United States Department of the Interior

U. S. GEOLOGICAL SURVEY
Interior Region 7 Upper Colorado Basin
Box 25046 M.S. 974
Denver Federal Center
Denver, Colorado 80225

SUBJECT: U.S. Geological Survey TRIGA Reactor, Docket Number 50-274, License Number R-113, License Amendment Request 2020-01, Supplemental Information Provided in Response to NRC Project Manager Phone Call on 2020-08-11 at 0900 MT and Organizational Chart Update.

Proposed Technical Specification Figure 6.1, Organizational
Chart

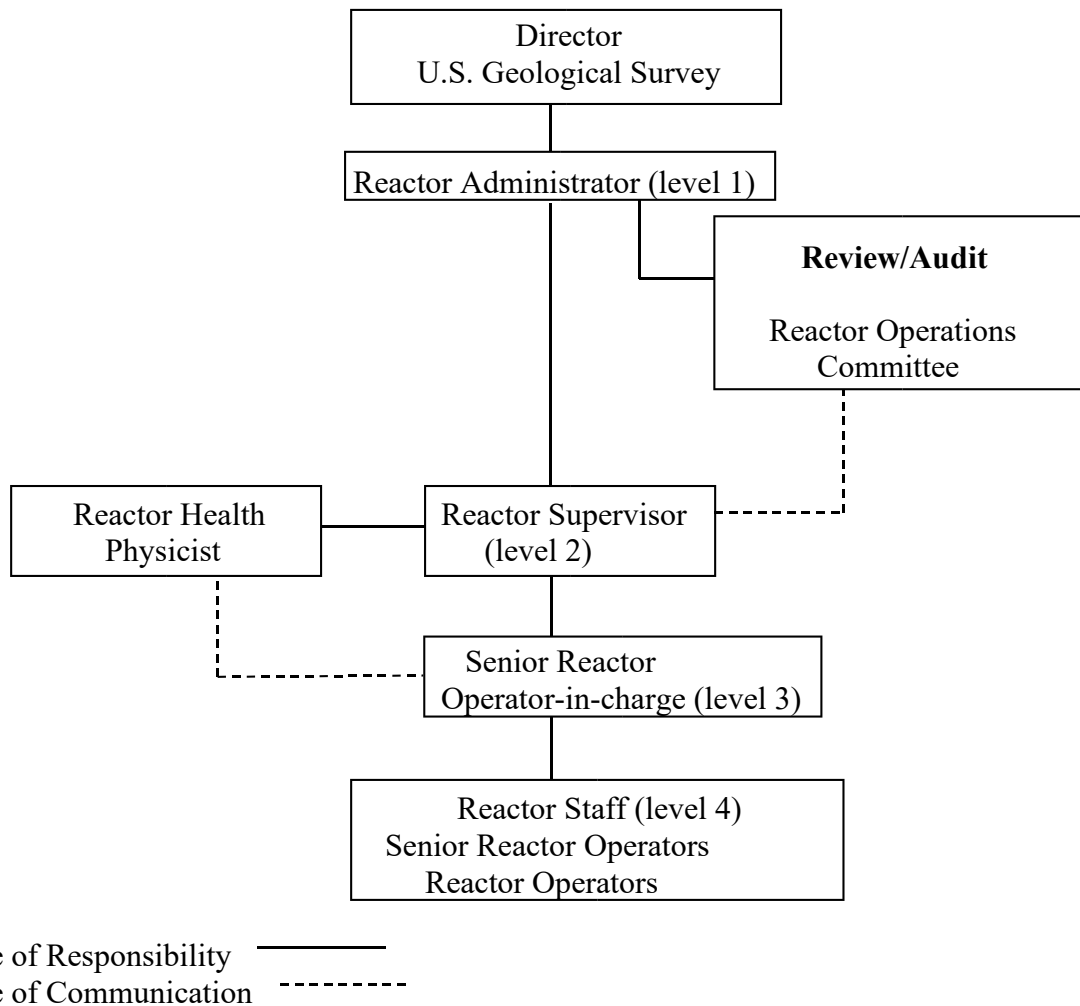
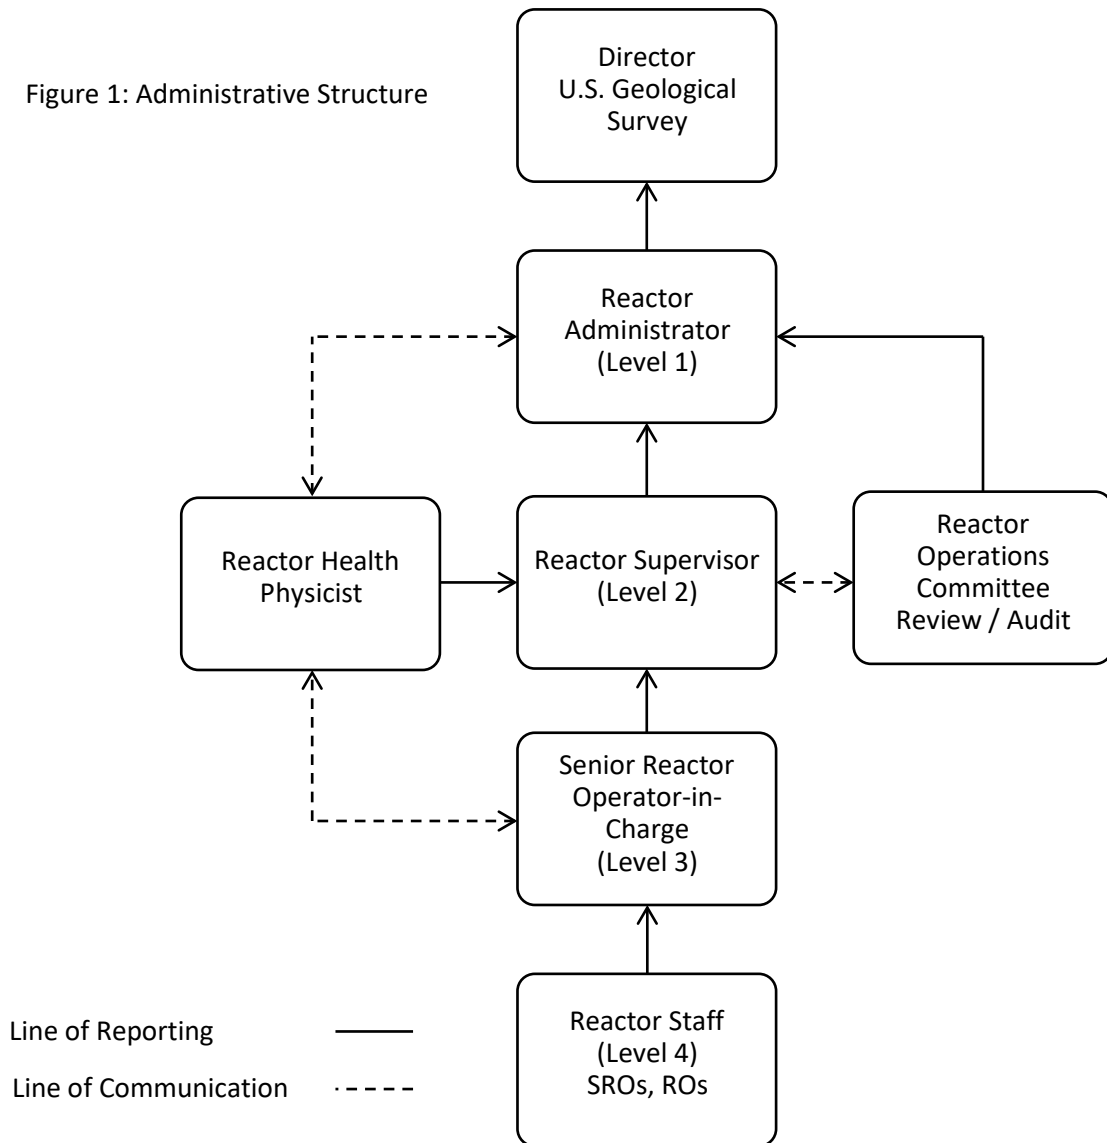
2. A change to the organizational chart, Figure 6.1 in the technical specifications, is submitted for approval and acceptance. This change provides two major items.

- a. First, a new communication line is drawn between the Reactor Health Physicist and the Reactor Administrator (Level 1). This change is being made to address a perceived conflict of interest resulting from a lack of communication between the two positions. Several reports including a TRTR community peer review and Department of Interior investigations have made recommendations for an additional path of communication between the Reactor Health Physicist and entities besides the Reactor Supervisor (Level 2) to prevent the potential coercion by the latter and obedience of illegal orders by the former. By instituting an additional official pathway, the Reactor Health Physicist is able and encouraged to voice concerns as necessary. An internal organizational chart has also been updated to reflect such preventive measures.

- b. Second, directional arrows have been added to the organizational chart to clarify the reporting and communication hierarchy. This was a suggestion by members of the GSTR Reactor Operations Committee and determined to assist in interpreting the intent of the chart. Reporting lines have been kept single ended to demonstrate the intended chain of command and expected direction of information between lower levels and higher levels, as entities are not always placed on lower / higher levels with respect to one another. However, reporting lines also intrinsically represent a two-way path of communication, as superiors and subordinates must be able to converse for the organizational structure to be effective. Communication lines have been made double ended to show the two-way nature intended by those relationships and represent no explicit reporting requirements.
